CD-2023-264

**Subject: Federal Cell Facility Application: Responses to the Director's Request for Information –
DRC-2023-078530**

Appendix B: Federal I Cell Facility Engineering Drawings

DESIGNED BY	D. BOOTH
REVIEWED BY	N. CLARKE
APPROVED BY	D. BOOTH
DATE	AS NOTED 01/09/20
PROJECT NO.	14004 C05

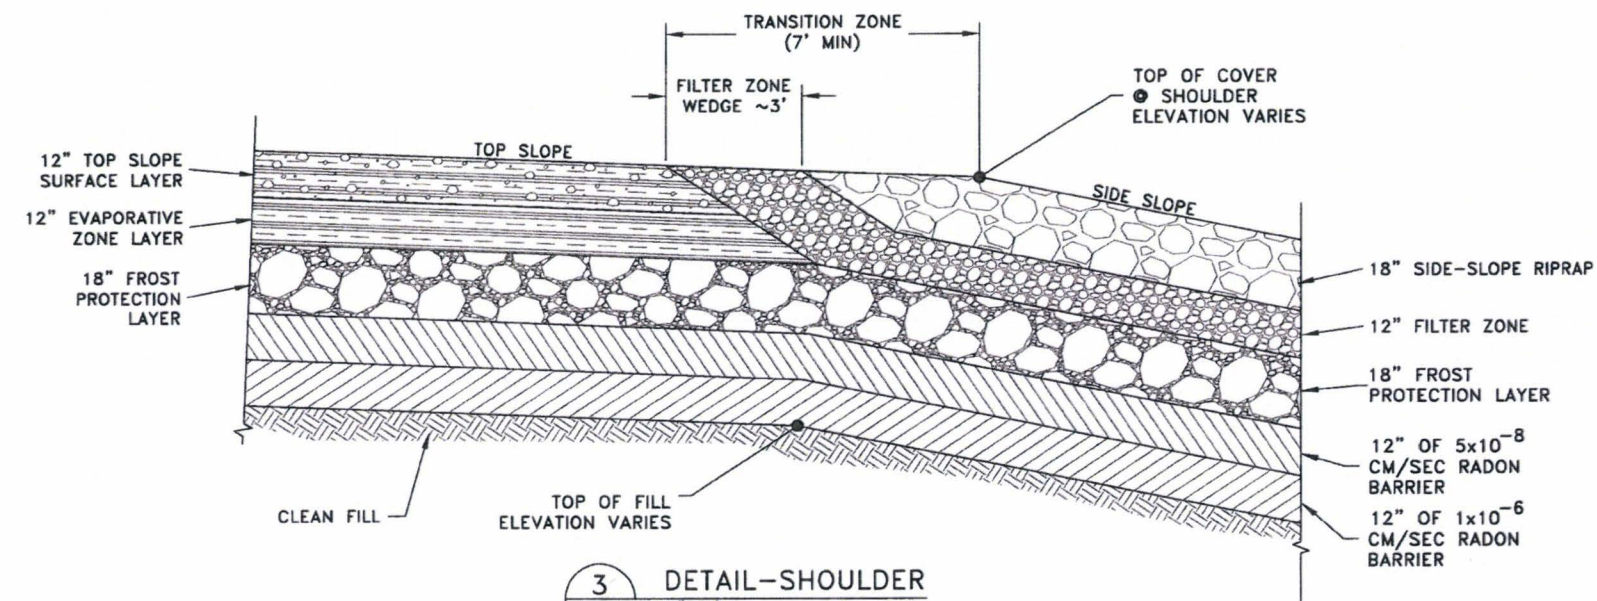
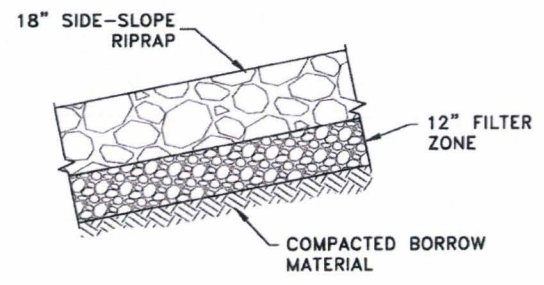
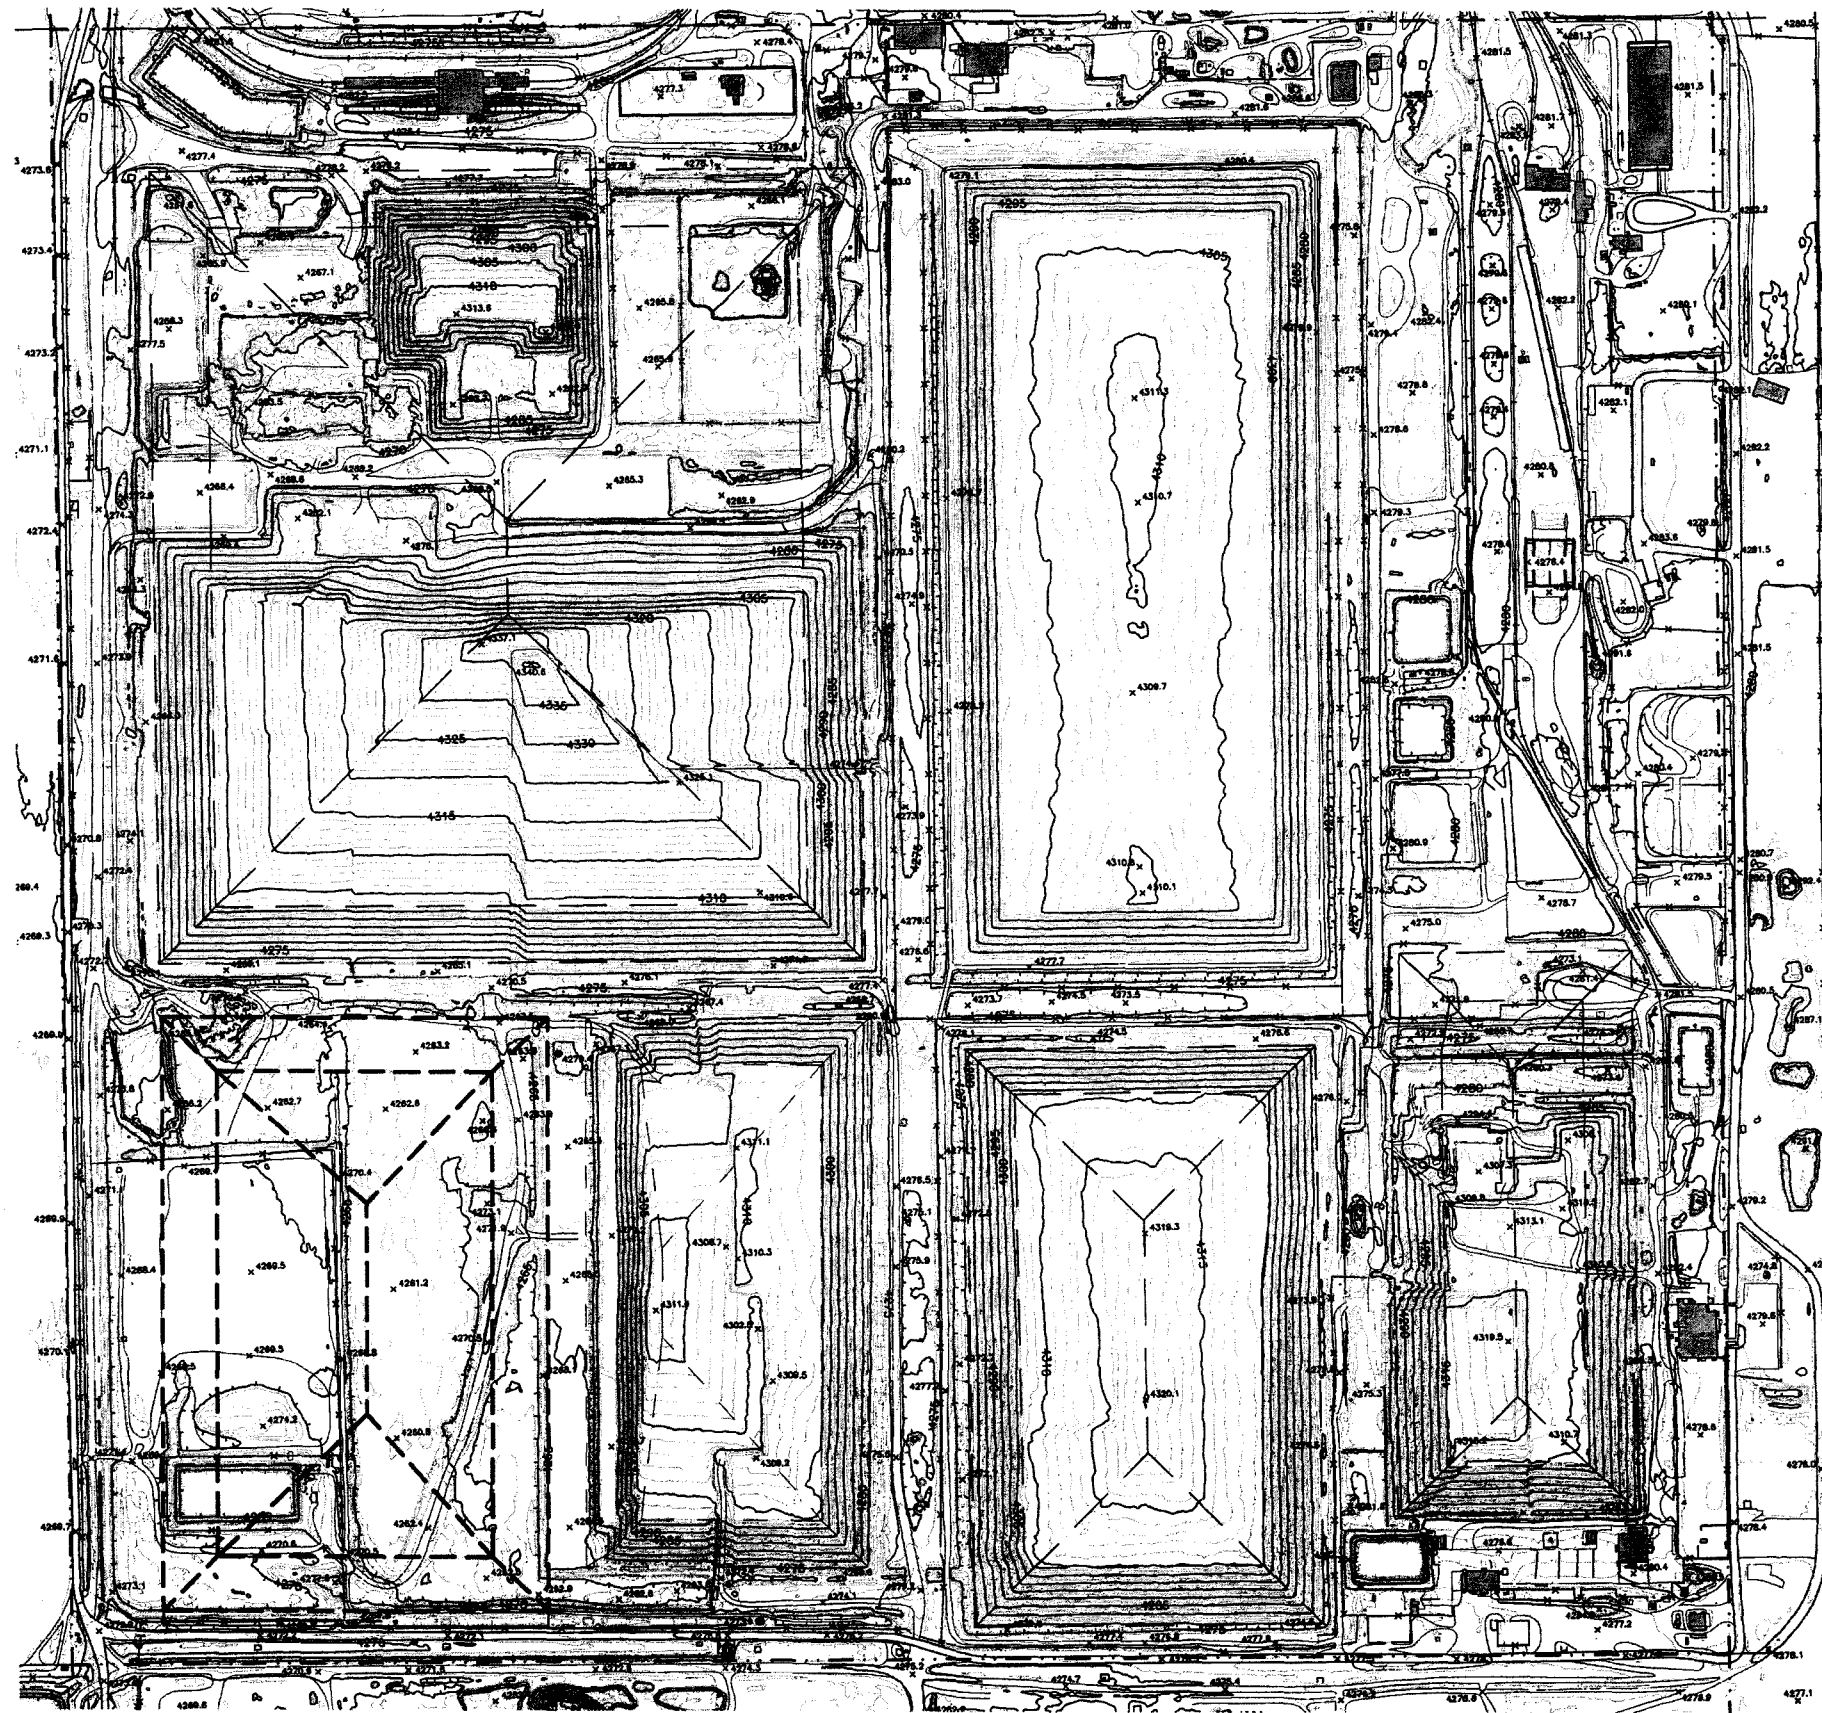
B-44: *No cross-section nor detail suggests that the filter zone will rest on the “natural ground.” Criteria should be established for subgrade material upon which cover material shall be placed atop. Please review RFI B-34.*

B-46: *Note (2) can potentially leave ambiguity to the seeding methodology. If EnergySolutions proposes seeding within the plan set, please provide additional information on “approved seed mixture and method” or reference where the reader may locate this information.*

Filter zone and subgrade detail have been added to Engineering Drawing 14004-C05.

Note (2) has been clarified on Engineering Drawing 14004-C05.

ENERGYSOLUTIONS	CLIVE FACILITY FEDERAL WASTE CELL EMBANKMENT LOCATION MAP & TOPO CLIVE, UTAH			
FINAL DRAWING				
DRAWN BY D. BOOTH	DATE 9/20/21			
CHECKED BY V. ROGERS	DATE 09/20/21			
DESIGNED BY D. BOOTH	DATE 09/20/21			
14004 L01

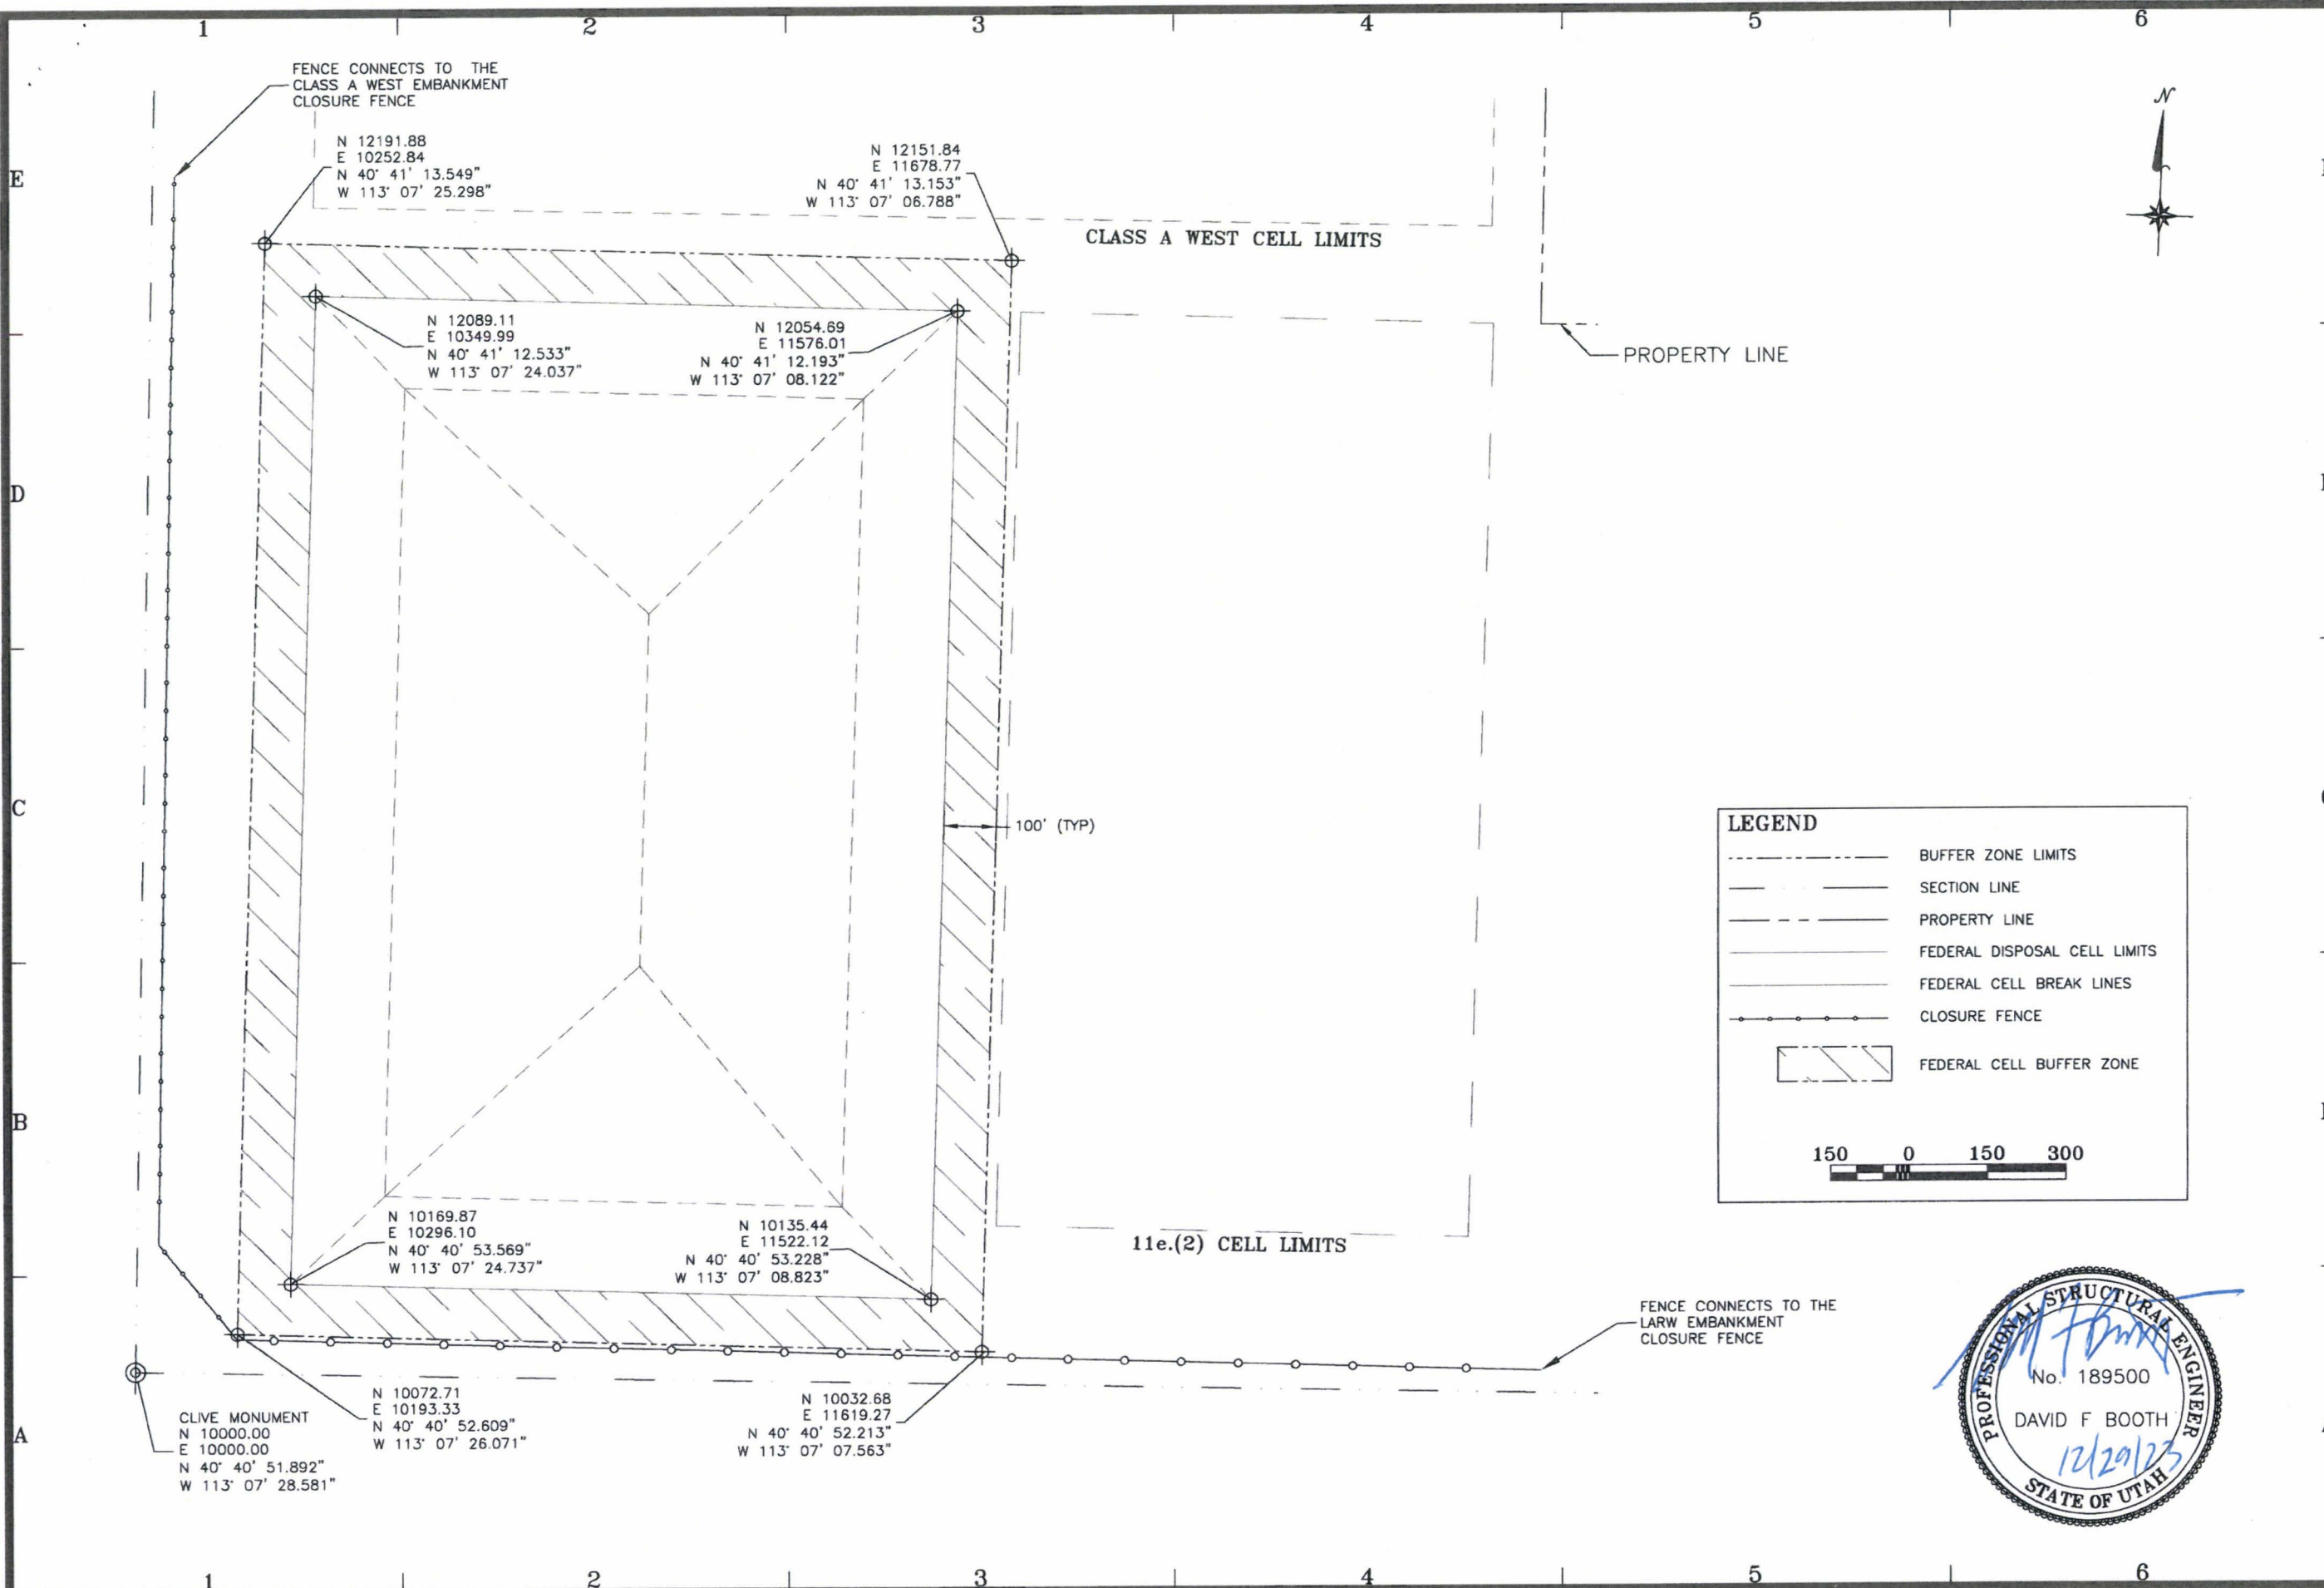
B-50: According to Section 3.1.11 within the text of the Application, the “Buffer Zone” is defined as “[...] buffer zone must be no less than 100 ft between the rectangle defined by the four control points that define the cell limits on Engineering Drawing 14004-U01 (Appendix B) and the perimeter fence.” It is unclear on this Sheet if the Buffer Zone adequately meets this minimum requirement due to the questionable scale of the drawing (refer to B-48), lack of dimensional callouts, and any additional notes that may provide clarity on the requirements that are highlighted in the text or relating Appendices. Please provide clarity on these characteristics at a minimum.

The Buffer Zone location has been clarified on Engineering Drawing 14004-L01.
